HOWARD COUNTY HISTORIC PRESERVATION COMMISSION

May Agenda

Thursday, May 4, 2017; 7:00 p.m.

This Agenda identifies the work proposed and includes comments and recommendations from DPZ Staff. The recommendations included here do not constitute a decision of the Commission.

Figure 10 - Amended deck plan

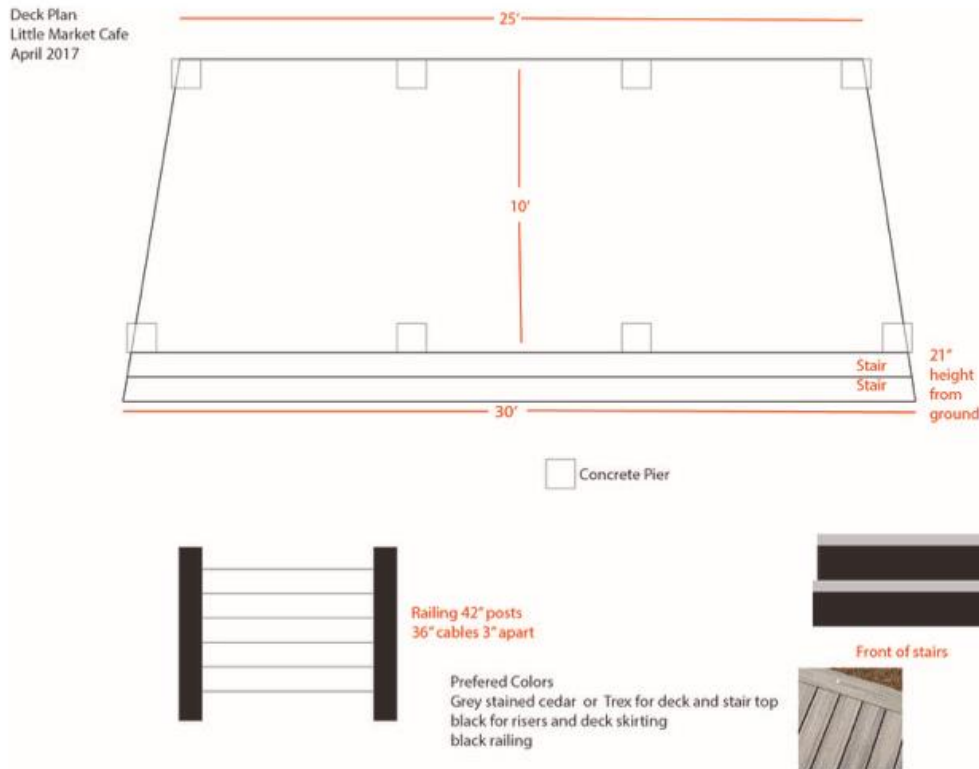
Staff Comments: This request is not for a typical deck, as it is not for a residential structure and it will be visible from the public right-of-way. Staff finds the proposal should be evaluated as street furniture, given the commercial location and purpose of the proposed deck. The proposal complies with Chapter 10.C of the Guidelines, which recommends, “use street furniture that is simple in design and constructed of traditional materials such as wood and dark metal” and “particularly along the commercial section of Main Street, place street furniture in areas where the sidewalk is wider or where adjacent public open space (such as the plaza next to the railroad museum) provides a more spacious public environment.” The proposed deck will be located in the private courtyard along Tonge Row, in an area where there is a more spacious environment, as recommended by the Guidelines. Staff finds the proposed use of Trex does not comply with the Guidelines.

Chapter 7.B of the Guidelines deals specifically with the construction of new porches and decks and recommends that they be “simple in design and should not alter or hide the basic form of the building.” The proposed deck will be detached from the building and is more of a landscape feature/patio for the commercial use of the area.

Staff discussed this application with the Department of Inspections, Licenses and Permits as this portion of the property appears to be in the floodplain. The deck may not be able to be constructed because of this, but if it is allowed, will be required to withstand certain flood velocities.

Staff Recommendation: Staff recommends Approval contingent upon approval from the Department of Inspections, Licenses and Permits and the Department of Public Works, and that cedar wood should be used. Staff recommends Denial of Trex decking and stairs.

Figure 11 - Plans from 1989

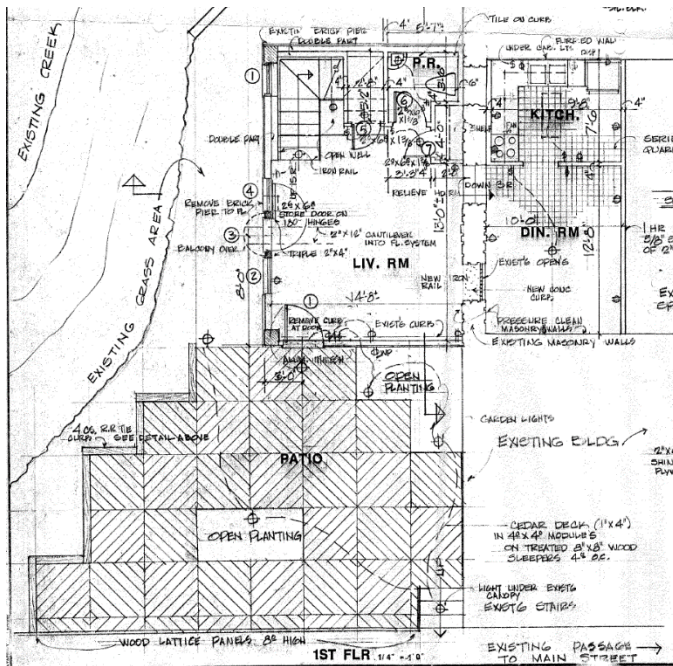
As seen in Figure 11, the plans from July 1989 were for a smaller deck than what was destroyed in the July 30, 2016 flood. At some point the deck was expanded beyond the original approval, which also did not include privacy walls.

Figure 17 - Proposed vinyl railing

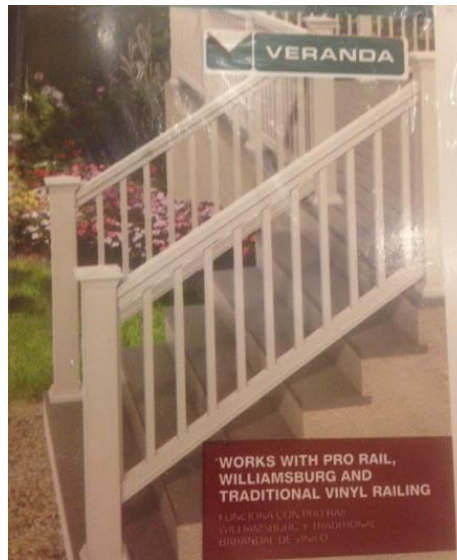
The Applicant proposes to install a wood board on board fence and sliding barn door along the wall shown in Figures 14 and 15 and a brown vinyl railing along the stairs shown in Figure 13 and 14. Staff finds this proposal uses too many materials and recommends simplifying the application to using a black iron or aluminum railing along the wall and staircase. There are several styles of simple black metal railings that have been used throughout town that would better complement the stonework on this patio than the wood board fence and vinyl railing. Chapter 9.D of the Guidelines recommends, “install open fencing, generally not more than five feet high, of wood or dark metal. Use closed wood fences only for side and rear yards in areas where a precedent exists. Construct closed wood fences of painted vertical boards, with straight or angled rather than scalloped tops.” Staff does not find a precedent exists for a closed board fence in this location and finds an open black metal fence would better complement the space and function in the same manner as the closed board fence. A privacy fence is unnecessary in this location as the patio looks to the side of a building and Staff was told by the Applicant that the patio would have no commercial use on it.

Staff Recommendation: Staff recommends retroactive Approval as submitted for the work that has already been done to the stone wall, patio and rear addition. Staff recommends retroactive Approval of the enclosures of the doorways, the additional windows added to the building, and the switching of the door to a window. Staff recommends Approval of the proposed lighting fixtures. Staff recommends Denial of the proposed vinyl railing and board on board fence and barn door. Staff recommends an alternate railing and fence style, such as a black metal fence, be used.

Figure 23 - Existing conditions

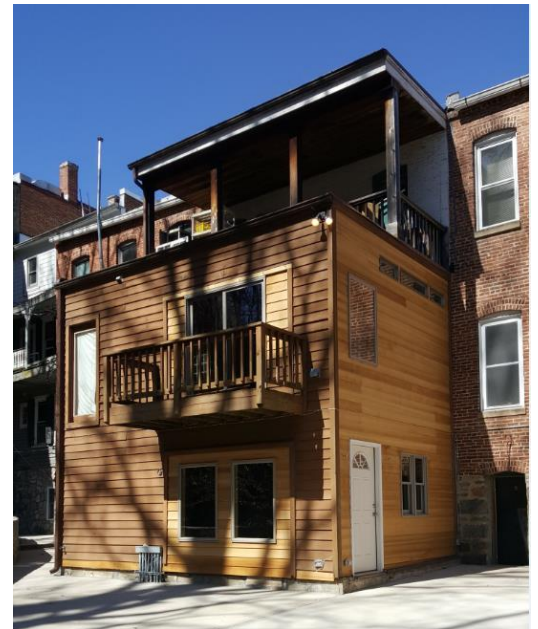
The Applicant has stated that the repairs to the rear were in-kind to match how the building has looked for the last 22 years, other than changing a door to a window for safety. The Applicant said the addition was most likely not built according to the approved 1989 plans. The rear addition, as seen in Figure 23, is modern in design and the alterations to the approved plans are not drastic. However, the entire side of the building has been resided and the two back door openings, including the second floor balcony, have been enclosed with cedar siding, reducing the openings. There should be three door spaces opening on to the deck, instead there are two. There should be the same three openings below the deck, instead there are two windows. While the details are slightly different, the symmetry remains the same and the integrity of the building is not affected by the changes. The side of the building has two windows that are not on the approved plans. The window above the door is supposed to be a door with a small Juliette balcony; however, the existing window is less intrusive. The paired windows to the right of the door are not on the drawings but match the other windows in design and style and do not detract from the building's integrity. The alterations comply with Chapter 7 recommendations for new construction additions.

Figure 30 - Existing conditions

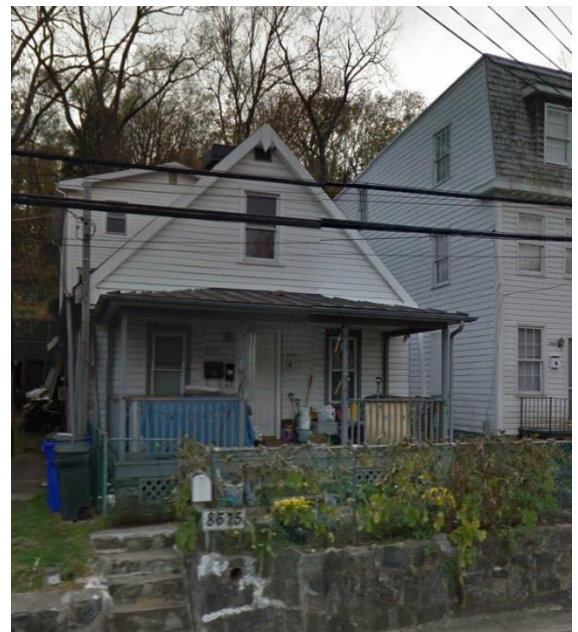
The existing roof is not historic and is already an asphalt shingle. The proposed replacement roof complies with Chapter 6.E recommendations, "...use asphalt shingles that are flat, uniform in color and texture and of a neutral color." The porch roof is a metal roof and the Applicant said they are not proposing to replace it.

The proposed gutters will be white K-style, but Staff recommends half round gutters be used instead, as it is a more historically appropriate style. Staff relayed this information to the Applicant, who said they would prefer to use K style gutters since they have a larger capacity and are cheaper. The existing gutters appear to be in fine condition, but the downspouts do need attention. Staff recommends the Applicant reuse the gutters that are in working condition and only add new gutters and downspouts where needed. Chapter 6.E recommends, "use gutters and downspouts of painted metal or prefinished aluminum in a color consistent with the building's exterior walls or trim. Locate downspouts along natural vertical lines and corners of the building." The existing downspouts are somewhat tied into the corners of the buildings, but are a mismatch of styles and colors and need to be better affixed into the corners. Some of the gutters and downspouts appear to have been replaced when they were applied for in 2001, as seen in the photos submitted in 2004. However, by 2007 some of the downspouts appear to have been disconnected.

The application indicates that the current windows on the house are a mix of vinyl and wood. The Applicant proposes to replace all of the windows on the front portion of the house with wood Pella windows painted white. As mentioned in the case history above, the photographs and elevations from 2001 and 2004 show that the historic windows on the building have been removed without approval, and the window openings on the front and side appear to have been filled in with smaller windows inserted in the new openings. Chapter 6.H of the Guidelines recommends, "replace inappropriate modern windows with windows of appropriate style. If documentary evidence of the original windows is available, choose new windows similar to the original. Otherwise, select windows appropriate to the period and style of the building" and "restore window openings that have been filled in, using physical, pictorial or documentary evidence to accurately restore the building's historic appearance." Chapter

6.H of the Guidelines recommends against the changes that were done to the original windows. Staff recommends the windows be replaced with 6:6 windows, to match the windows that were removed without approval, and that the window openings be restored to the proper size on the front and side of the front portion of the building.

- 1) Staff recommends the windows on the front portion of the house be replaced with 6:6 wood windows to match the windows that were removed without approval, and the size of the window openings be restored to the original size.
- 2) Staff recommends wood siding be used on the front façade of the house and HardiePlank be used on the sides of the front portion of the house, as approved by the Commission in 2007.
- 3) Staff recommends the HardiePlank be the smooth instead of the wood grain, as painted wood siding does not have a wood grain.
- 4) Staff recommends Approval of the replacement roof as submitted.
- 5) Staff recommends the existing gutters in working condition be reused and new half round gutters and downspouts be added as needed.
- 6) Staff recommends Denial of K style gutters and downspouts, which are not historically appropriate.

Figure 37 - Current proposal

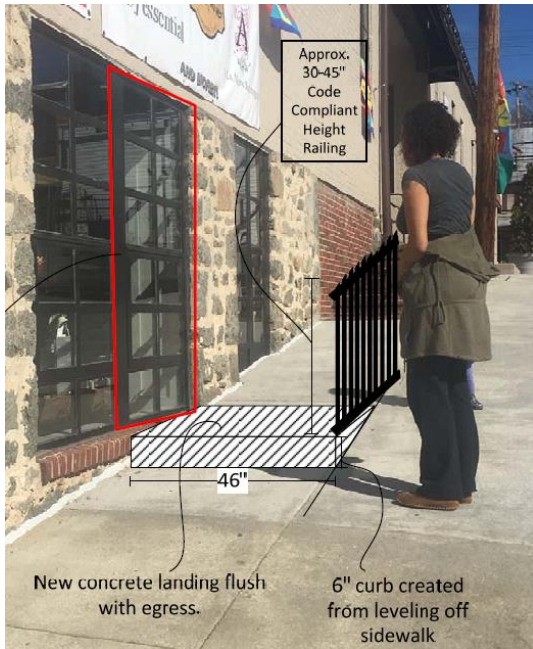
Staff Comments: Staff worked with DILP on this application. While the code does not explicitly require a railing of this arrangement, DILP did require this arrangement to properly identify the stairs and avoid a trip hazard. The application still complies with Chapter 9.D recommendations, “install open fencing, generally not more than five feet high, of wood or dark metal” and “construct new site feature using materials compatible with the setting and with nearby historic structures, particularly for features visible from a public way.”

Staff Recommendation: Staff recommends Approval as submitted.
